CITY OF VALDEZ
Project Title: New Well 5 Pumping Station
Project No.: 21-310-2538
Contract No.: 2406

SUBJECT: Addendum No.2

REVISED NEW WELL 5 PUMPING STATION

TITLE **BUILDING PIPING PLAN AND SECTION**

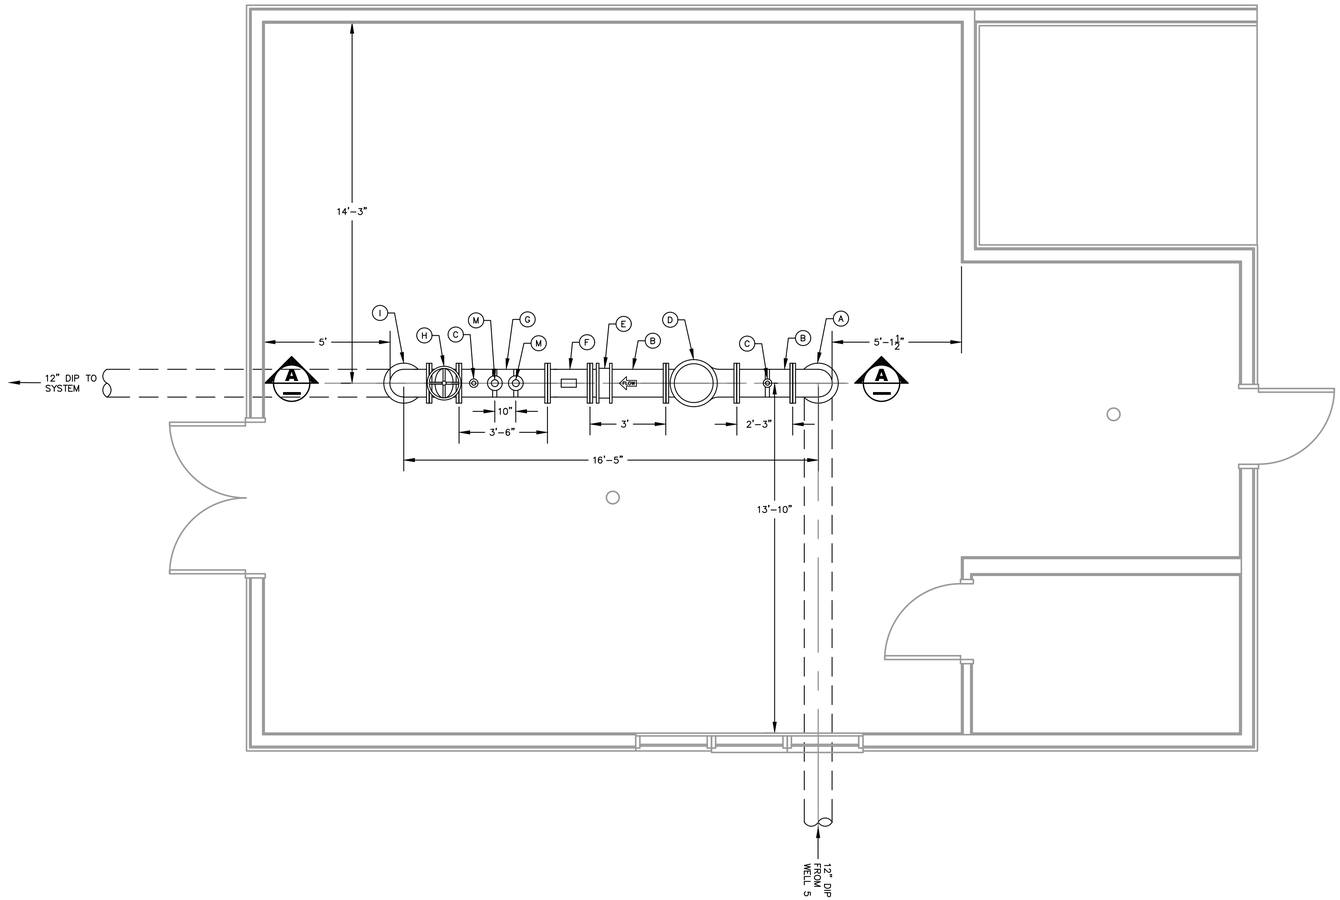
5. **Question:** Drawing M2 indicates 1-1/2" CW DN to Service Saddle. Drawings appear to indicate line drops into 2" Combination Air Valve. Please confirm size and location of tie-in at 12" DIP. Is the intent for tie-in to be at Item L 1" Service Saddle per C5?

APPRVL	REV	DATE	BY	REVISION
	2	9/23/2025	MU	ADDED NOTE FOR PAINT
	1	9/3/2025	MU	ITEM L MOVED TO OTHER SIDE OF CHECK VALVE AND CHANGED SIZE

Answer: 1-1/2" CW connects to item L service saddle, not the 2" combination air valve. Per Civil, the location of the service saddle is to be located after item L on the vertical portion of the 12" DIP. The service saddle is to be 1-1/2". See revised Civil plans moving Item L to the other vertical side of the 12" pipe and upsizing the saddle to 1-1/2". The tie-in is to be at new location of Item L.
